AGENDA

PLANNING AND ZONING COMMISSION WORK SESSION City Hall, 385 South Goliad, Rockwall, Texas Council Chambers May 28, 2019 6:00 P.M.

A101

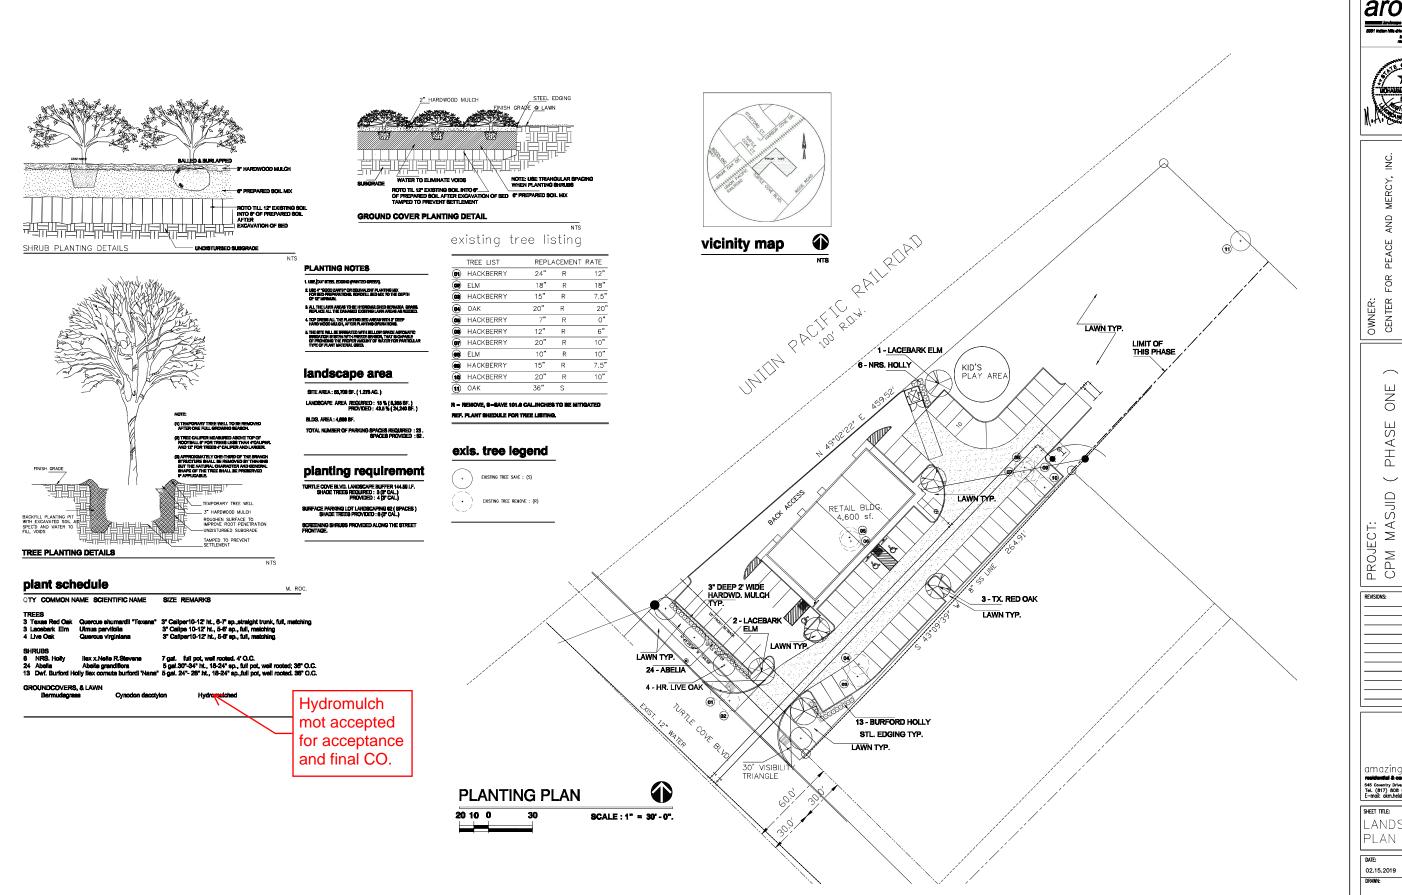
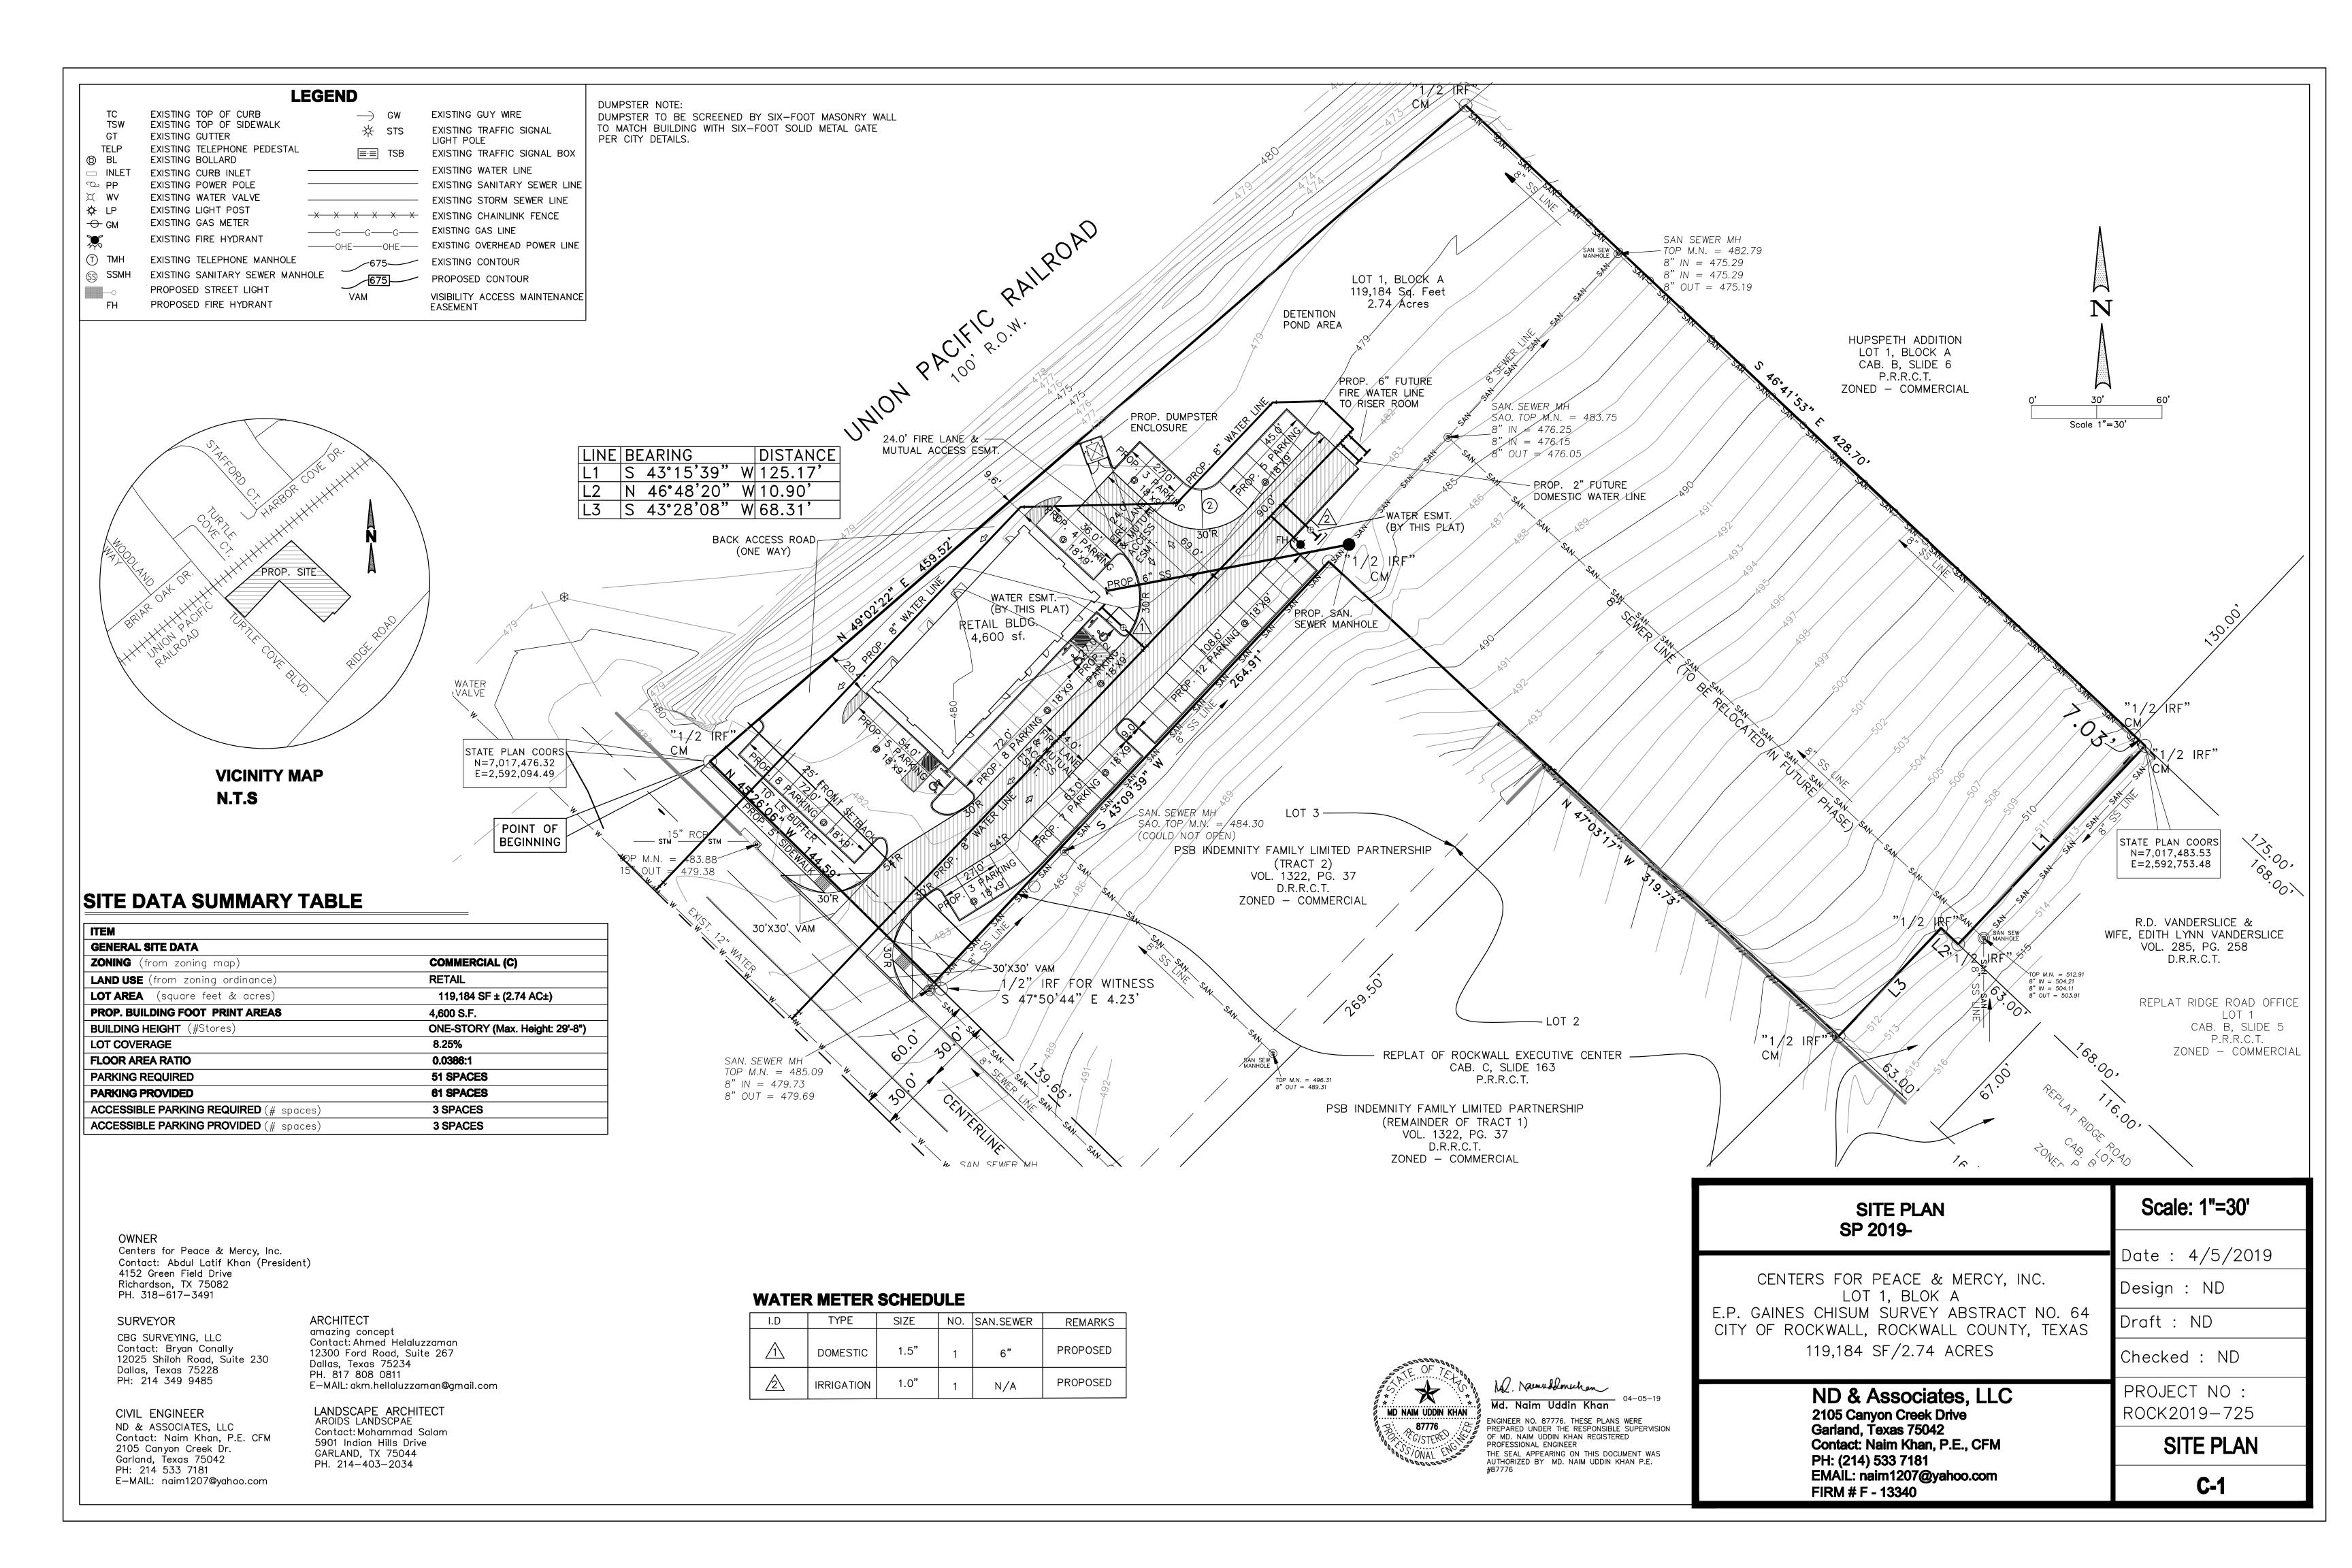
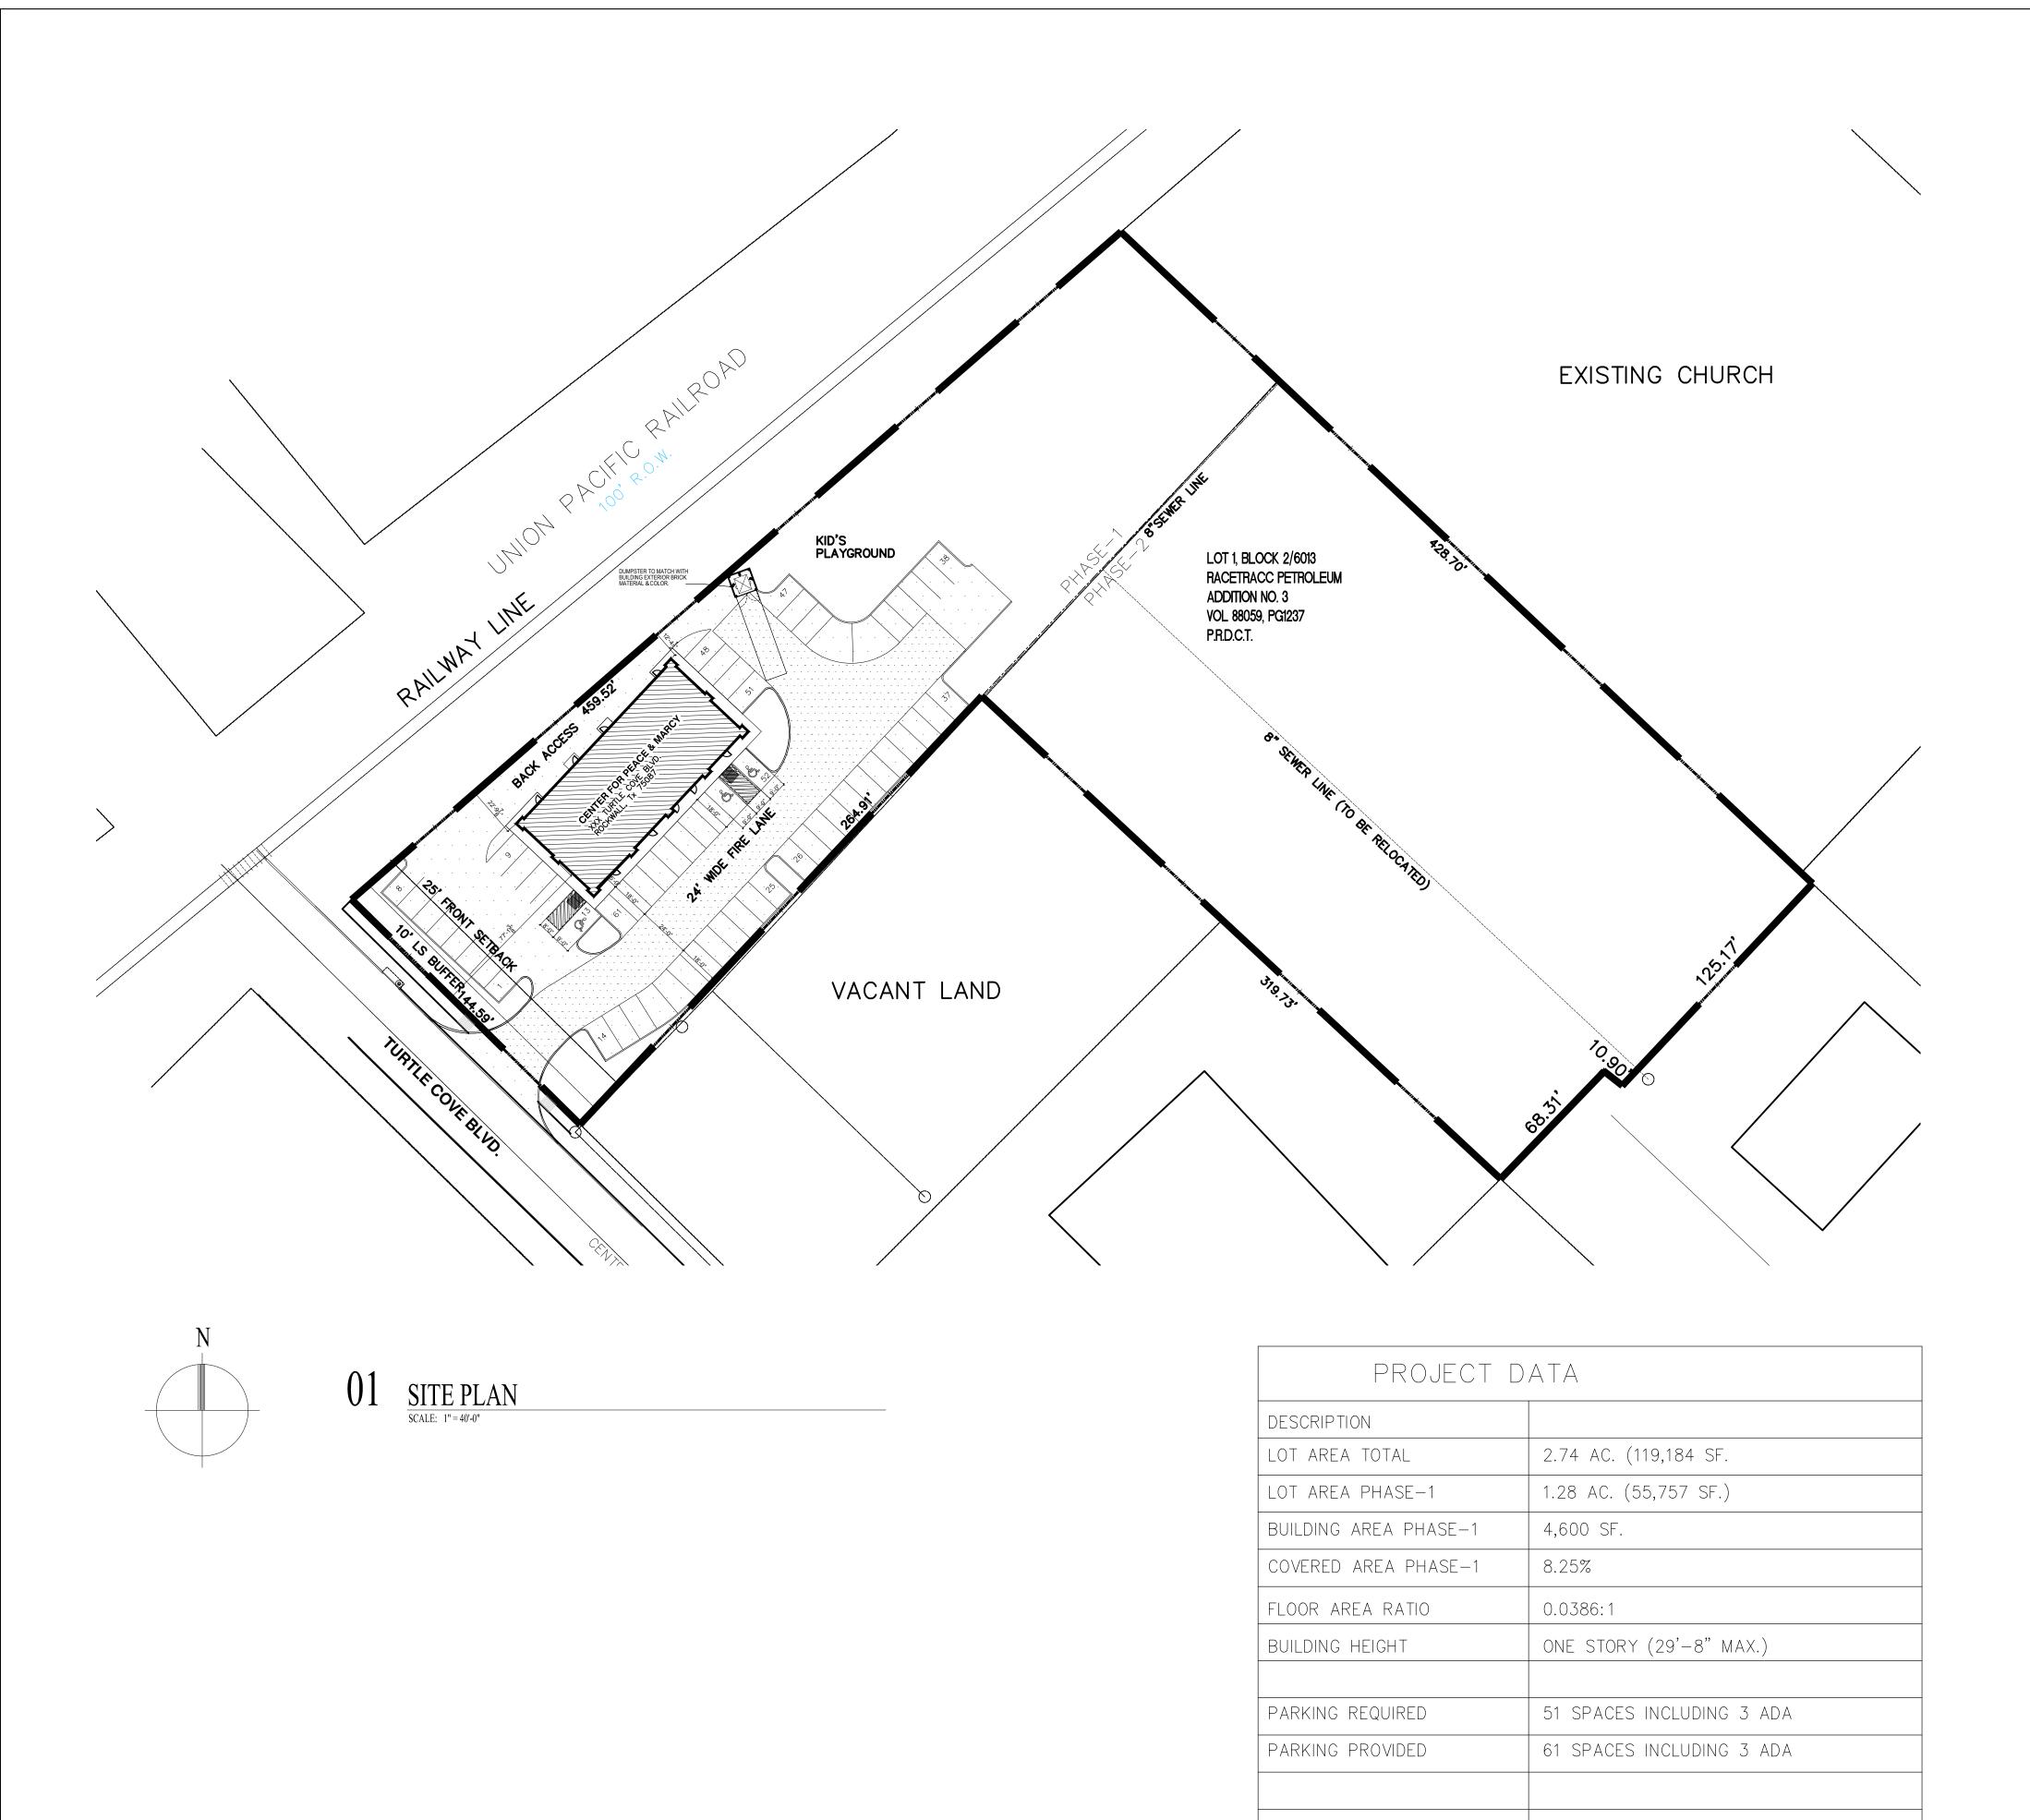
- 6. Sheet No. A101—This sheet doesn't seem to be necessary. The site plan on sheet C1 is the type of site plan that is needed. Please transfer site data table to remaining sheets.

- 7. Sheet C-1—Please note that in overlay district the dumpster screening is 8-feet, materials matching the main structure, with self-latching opaque gate.

- 8. Sheet C-1—There is a large amount of information on this sheet. Please greyscale topo and utilities.
- 9. Sheet C-1—Since there is large amount of lines on this page, could the firelane change from a hatch pattern to a solid grey? Show any remaining pavement, including sidewalks as a different shade of grey.

- 10. Sheet C-1—There is a reference to a "water easement by this plat" on the building footprint. Please remove along with any other plat references (e.g. the references to state plane coordinates). The plat will be taken care of at a later time.

- 11. Sheet C-1—Please use varying line weights and types to provide clearer differentiation. Also provide those changes in the legend. There are several items that use the same linetype.

- 12. Sheet C-1—Please show all proposed easements and extend of detention.
- 13. Sheet C-1—Please greyscale information on adjacent sites (i.e. any information that is not on your lots).

- 14. Sheet C-1—Please remove water meter schedule.
- 15. Sheet C-1—Please note that parking is 9x20.
- 16. Sheet C-1—Please revise access easements to "Public Access" instead of "Mutual"

- 17. Sheet C-1—Please remove symbols for IRF/similar
- 18. Sheet C-1—Please show division of worship area vs retail.
- 19. Sheet C-1—The parking close to the RR and Turtle Cove is dead end and will probably need a turnaround to allow vehicles to back out of the space.

- 20. Sheet C-1—No parking space shall be more than 80-feet from a canopy tree.
- 21. Sheet C-1—The site plan shows three or four thick grey lines that are not labeled. Some are adjacent to the property line and one is adjacent to Turtle Cove. What are these lines? Also there are several lines in the ROW that are not labeled. Please try to label all lines.

- 22. Sheet C-1—Will the two lots be combined?
- 23. Sheet C-1—What are the two pie shaped "parking spaces" near the play area? They cannot be parking spaces; however, I cannot determine what is being shown.

- 24. Sheet C-1—Please note that the landscape buffer is 20-feet and the building setback is 15-feet.
- 25. Sheet C-1—Please provide dimensions of all walls.

- 26. Sheet C-1—Please provide dimensions from building to all property lines.
- 27. Sheet C-1—Please note that the building does not meet horizontal articulation requirements as drawn and will need a variance. Please review Commercial articulation requirements.
